CASE FILE #PL201700278

Westwood Community Church Space Proposal: 6301 Cecilia Circle Building

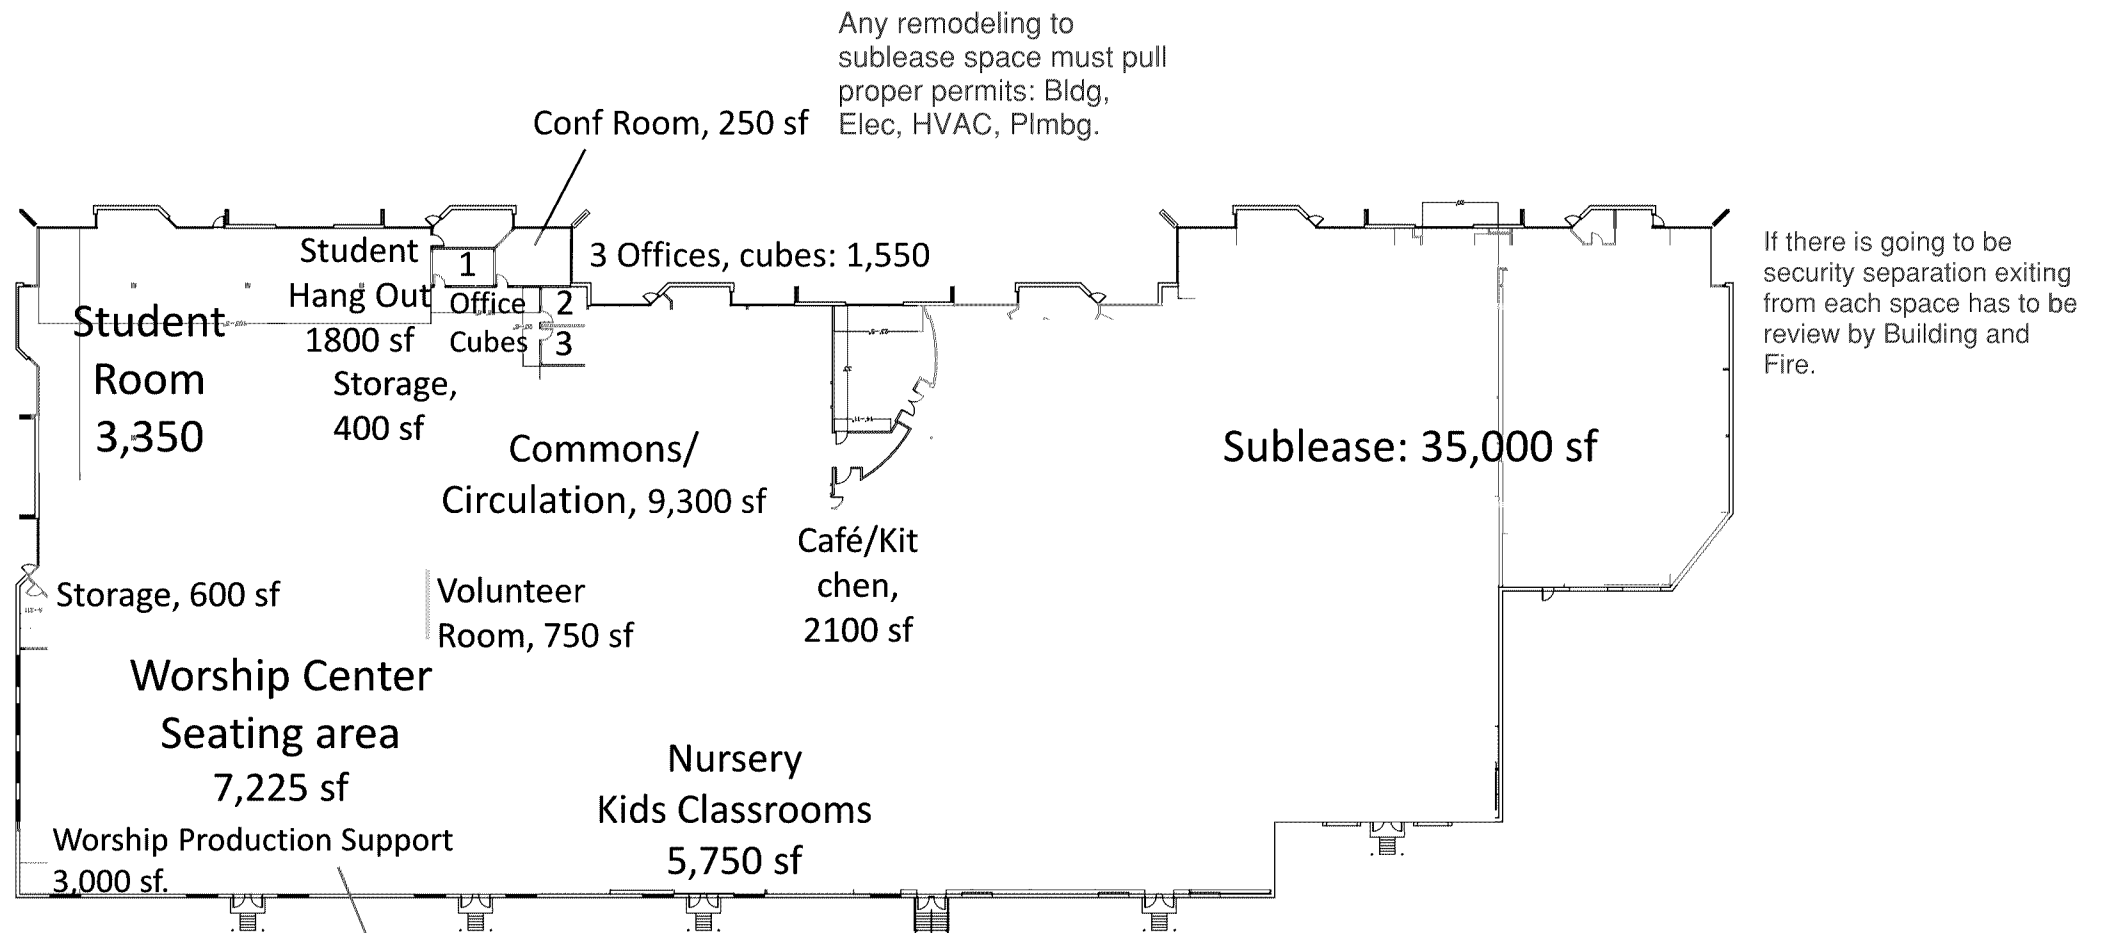
Provide a site plan so parking lot can be reviewed.

If there is going to be security separation exiting from each space has to be review by Building and Fire.

Nursery required to meet the requirements of an E or I occupancy if used on a day to day basis.

Fire alarm system required to meet the design for an assembly occupancy.

Environmental Health, Mechanical and Fire will evaluate cafe plan to determine hood ventilation and suppression system requirements.
